## Landscape Referral Response

<b>Application Number:</b>	REV2021/0035
<b>Date:</b>	08/10/2021
<b>Responsible Officer:</b>	Julie Edwards
<b>Land to be developed (Address):</b>	Lot 82 DP 10782 , 114 Whale Beach Road WHALE BEACH NSW 2107

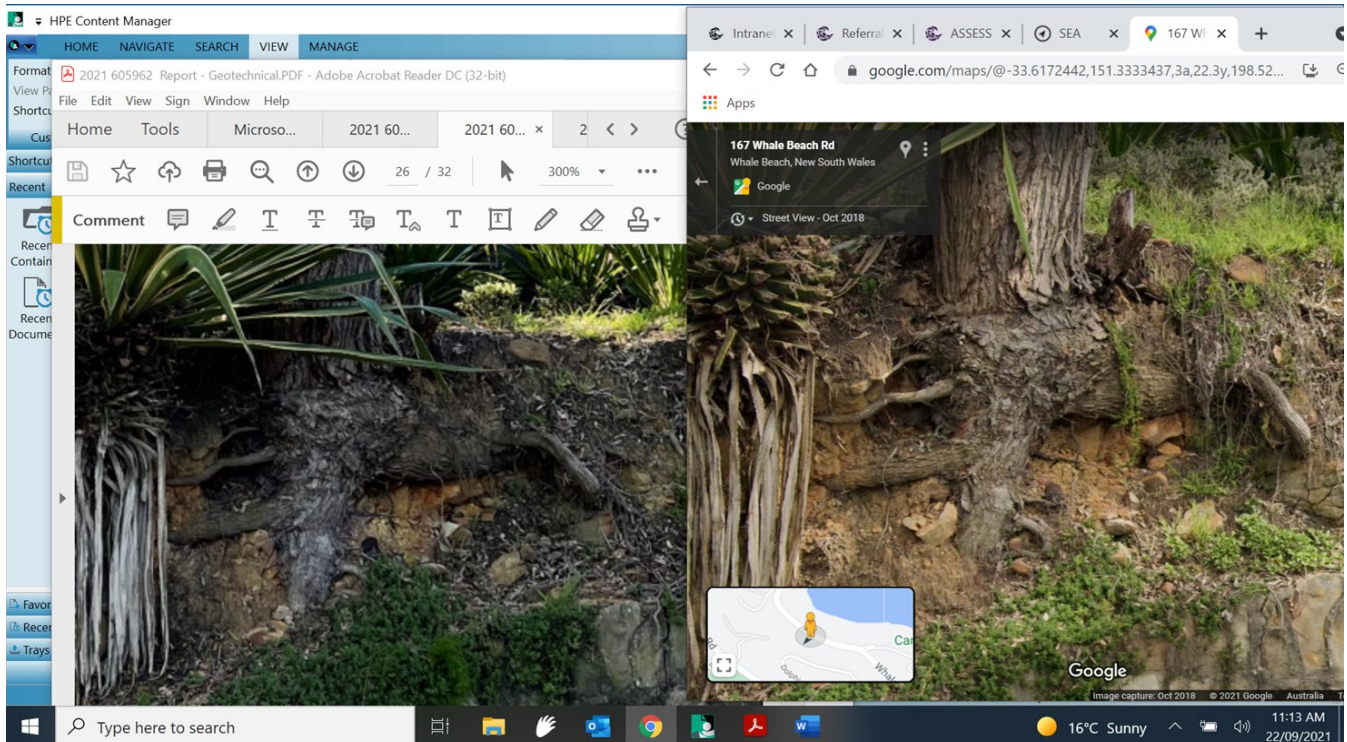
The tree has been located on top of the embankment and though some structural roots are exposed, it appears to have been in this condition for some time and appears stable at present.

Below is a comparison of the exposed roots as currently exists on the left side photo (Source: Geotechnical Report dated 1 April 2021 prepared by AssetGeoEnviro) with street view image from

2018. (Source Google Maps, 2018).
